ISC-C1 Rack

Title ISC System Wiring Diagram		
Size B	Number D1900511	Revision V9
Date: 10/31/2023	Sheet of 1	38
File: C:\Users\...ISC_C1_SH1.SchDoc	Drawn By: Filiberto Clara

Title			
ISC System Wiring Diagram			
Size	Number	Revision	
B	D1900511	V9	
Date:	10/31/2023	Sheet of	38
File:	C:\Users\...ISC_R5_SH1.SchDoc	Drawn By:	Filiberto Clara

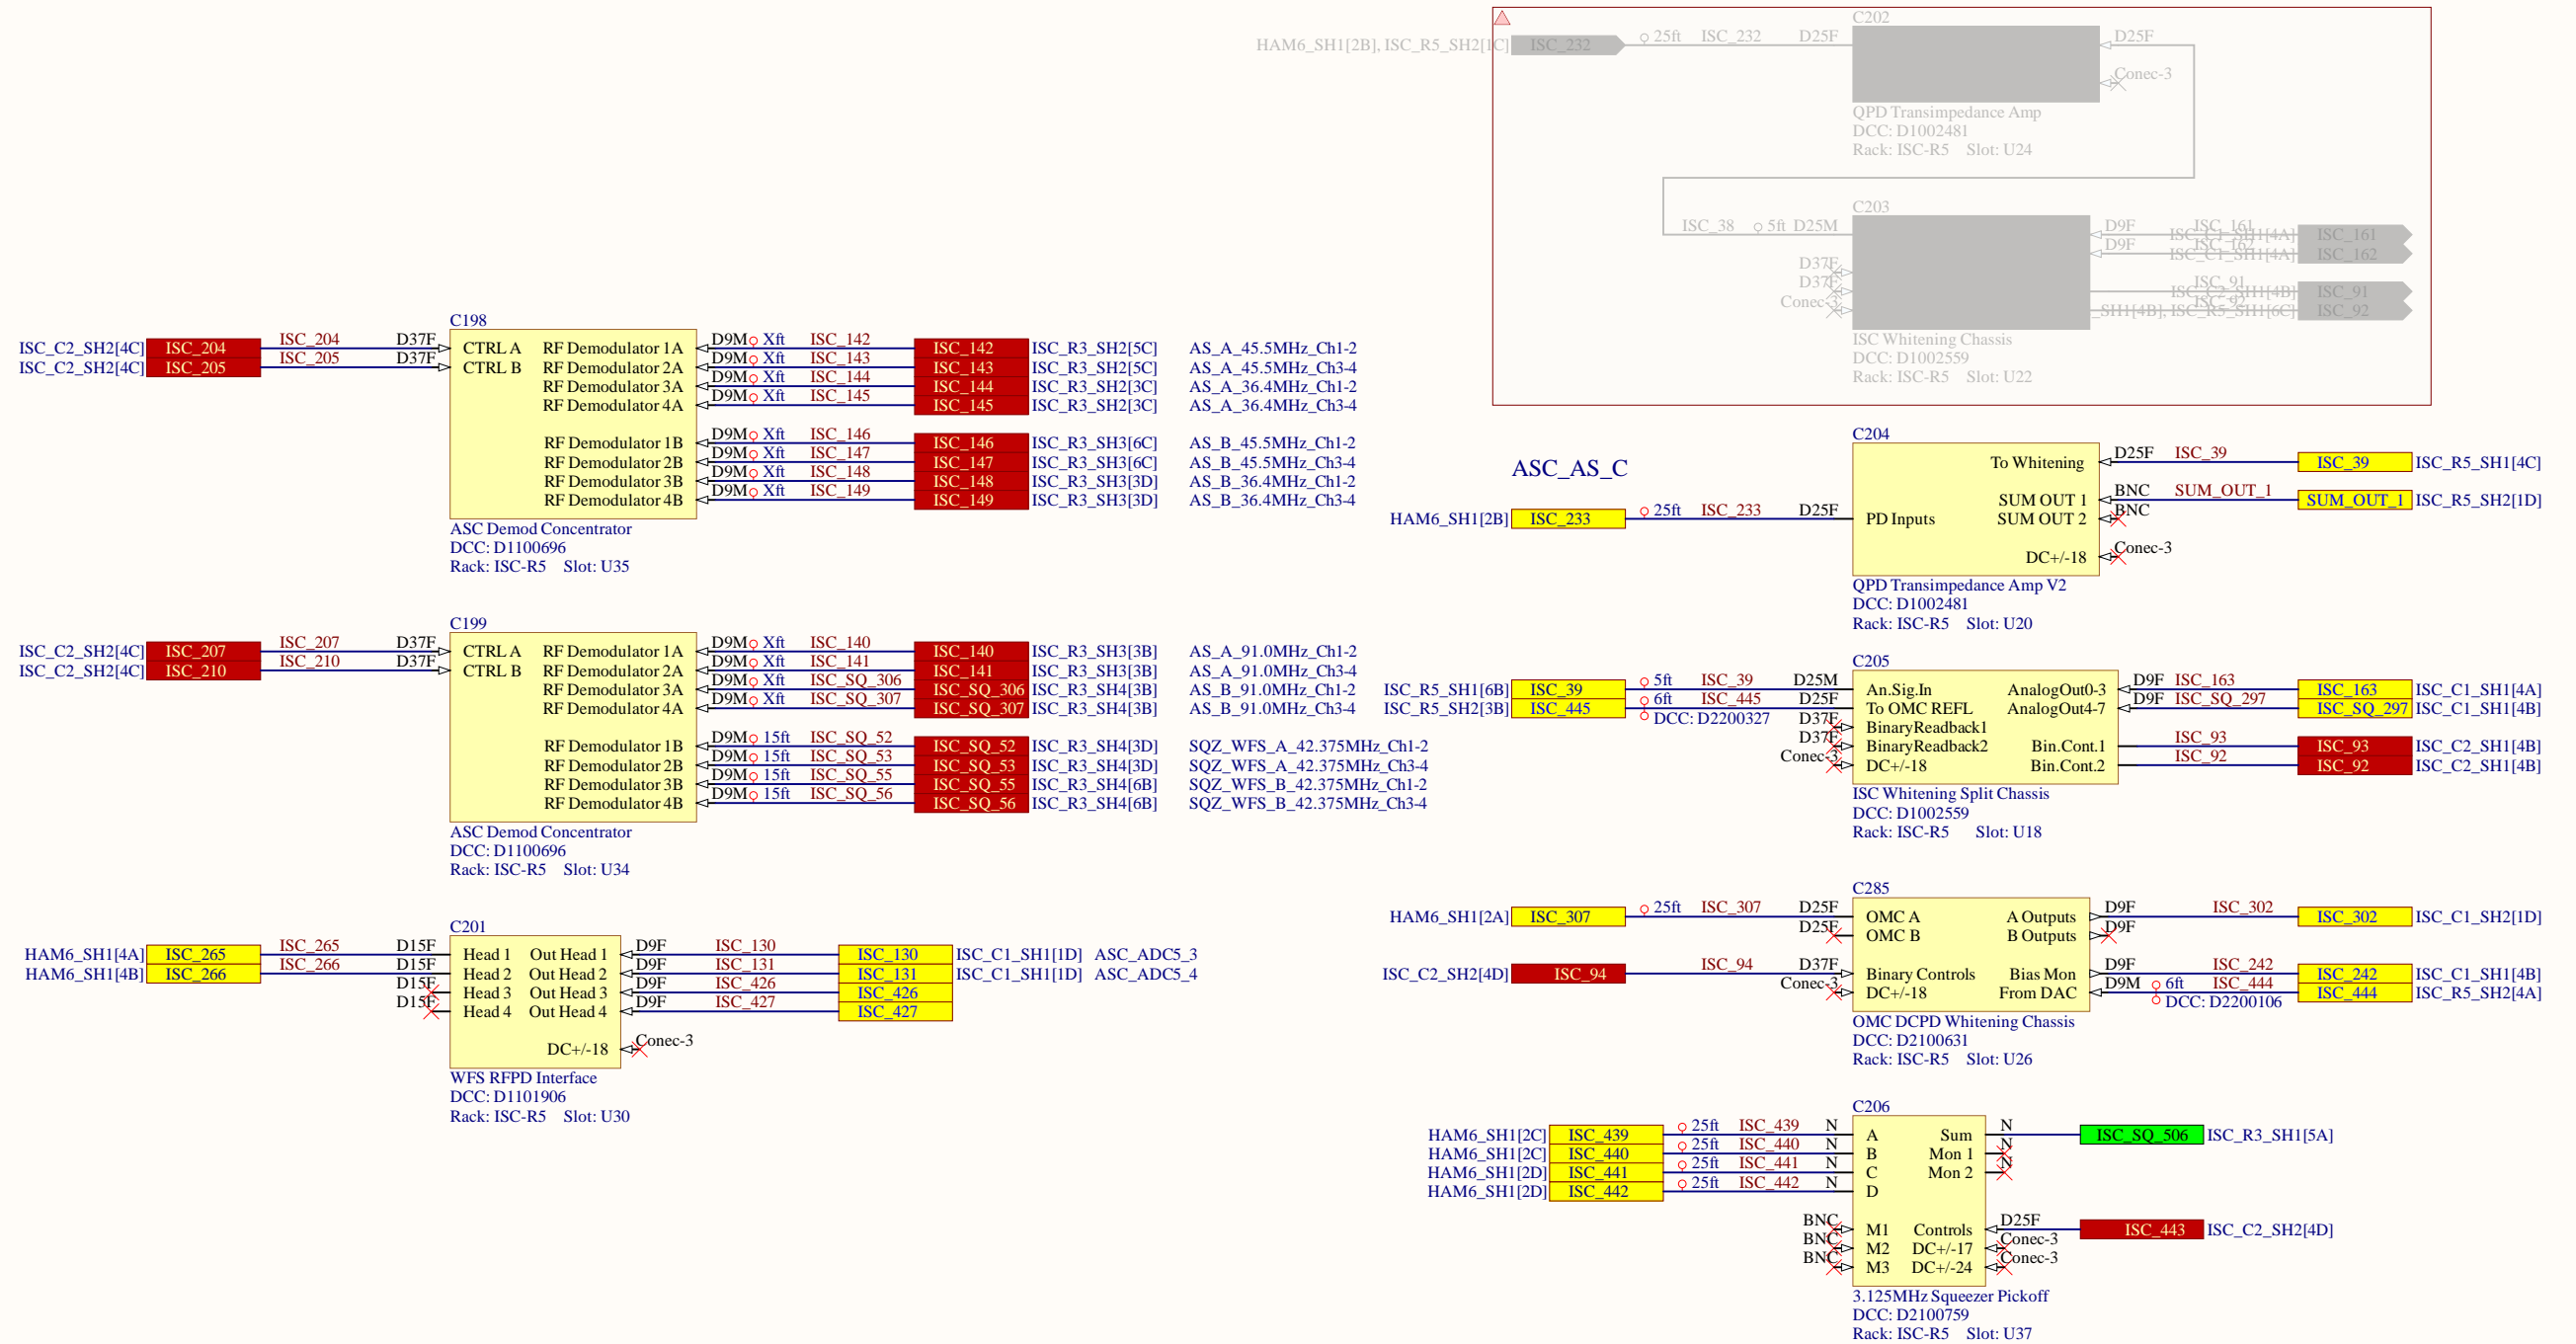
OMCR no longer used at LHO

Title		
ISC System Wiring Diagram		
Size	Number	Revision
B	D1900511	V9
Date:	10/31/2023	Sheet of 5 38
File:	C:\Users\Filiberto\IOT2_SH1.SchDoc	Drawn By: Filiberto Clara

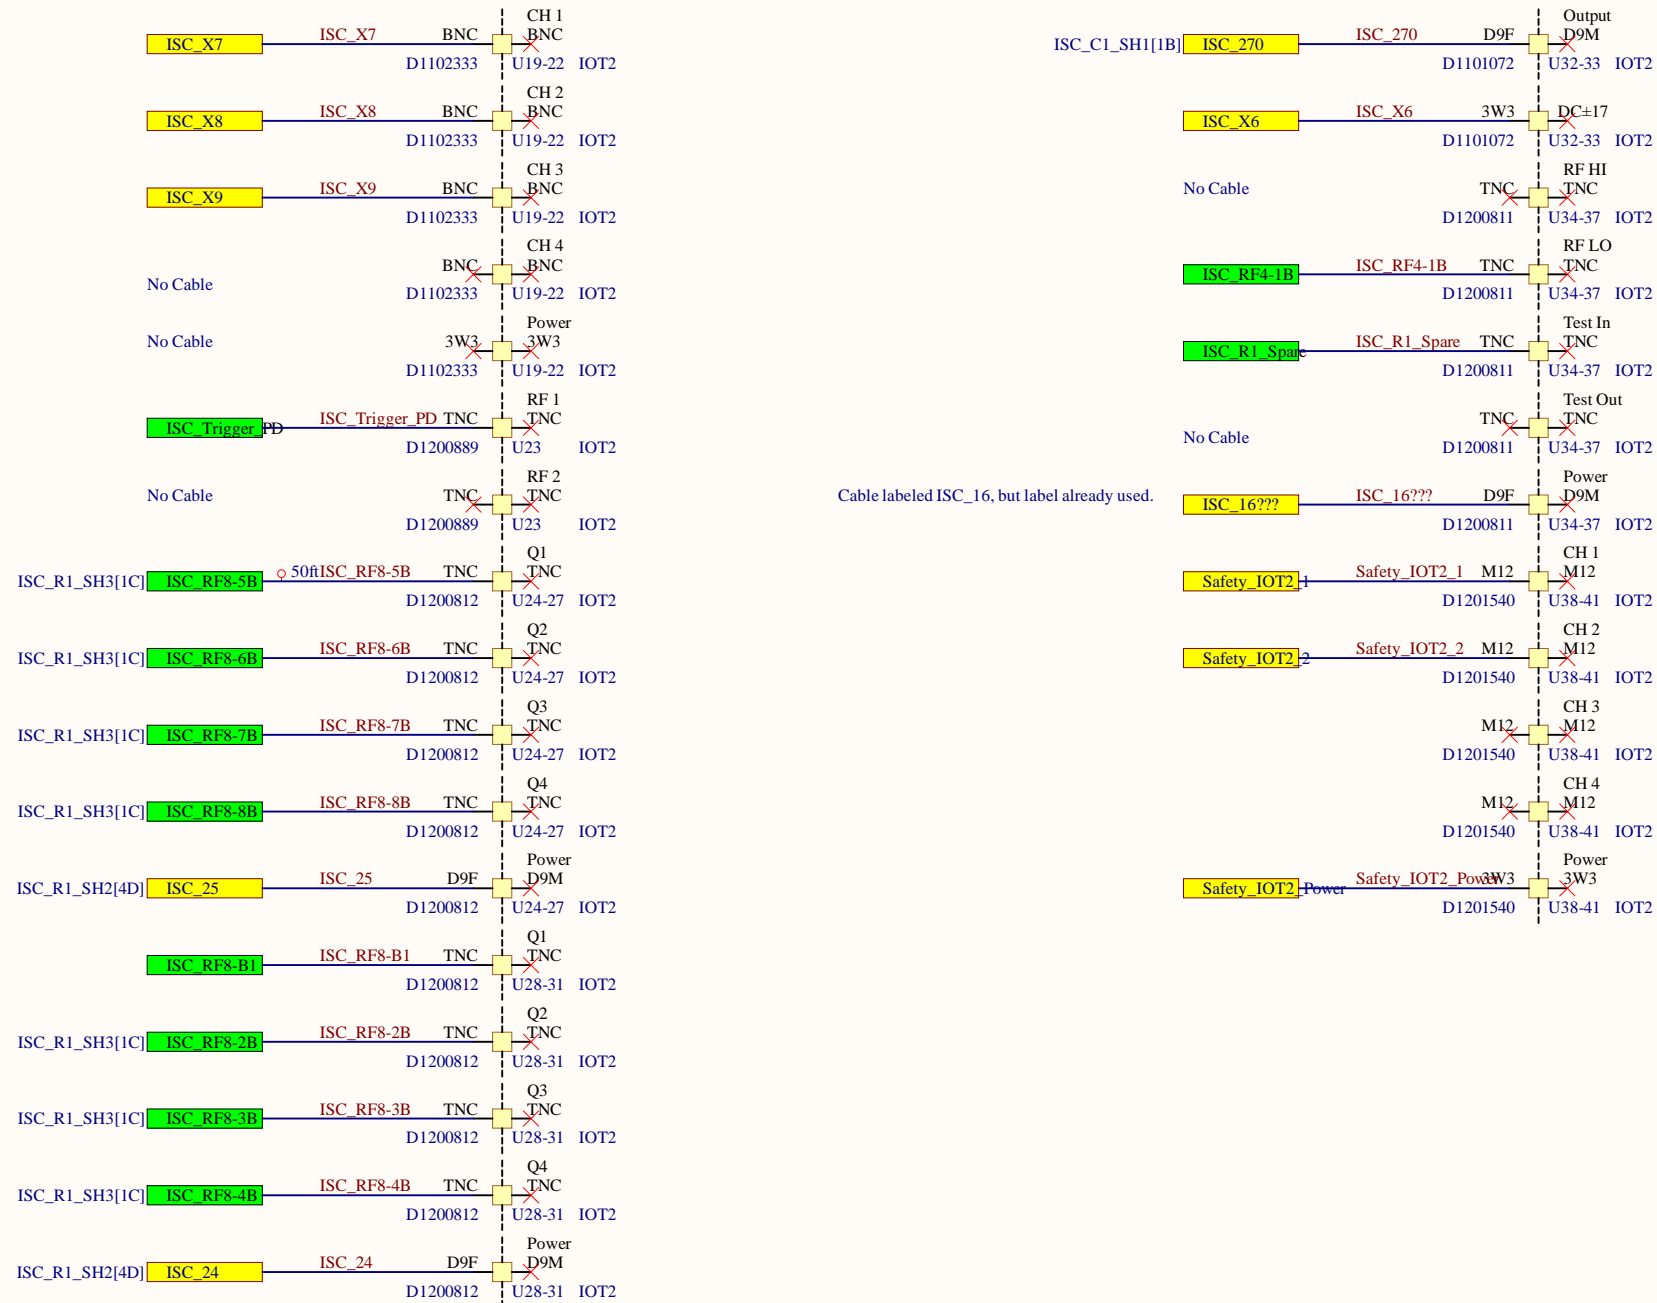
Cable labeled ISC_16, but label already used.

Title		
Squeezer RF Distribution		
Size	Number	Revision
C	D1900511	V9
Date:	10/31/2023	Sheet of 31 38
File:	C:\Users\...SqueezerRfDistribution.SchDpDrawn By: R. Abbott

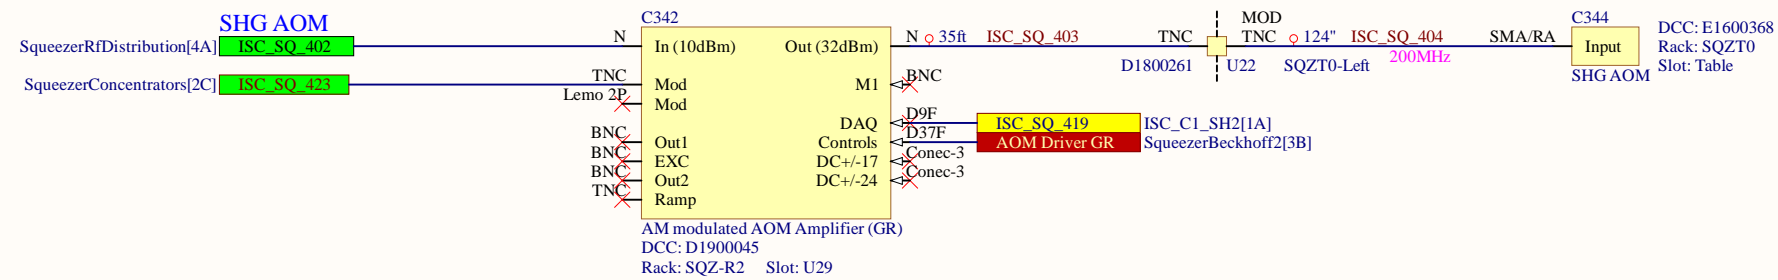
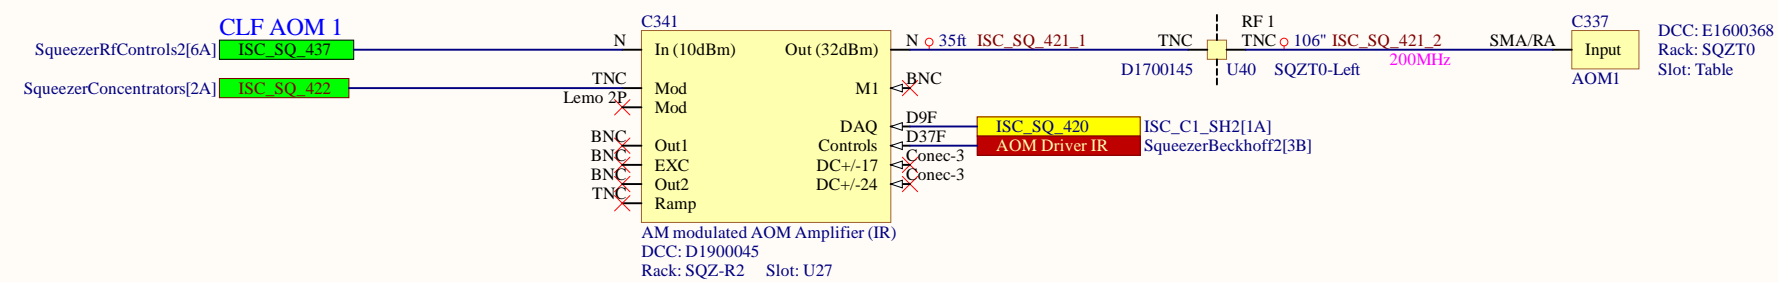
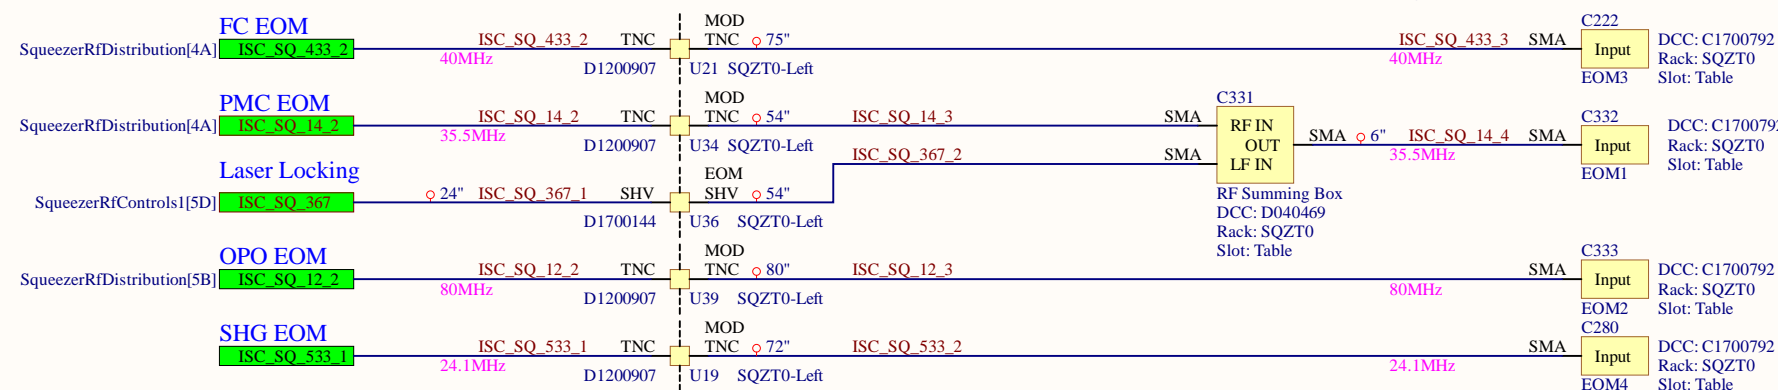
New cables for A_ start at ISC_SQ_430

RF cables carrying the AOM signals need to be 1/4" superflexible helical corrugated coax.
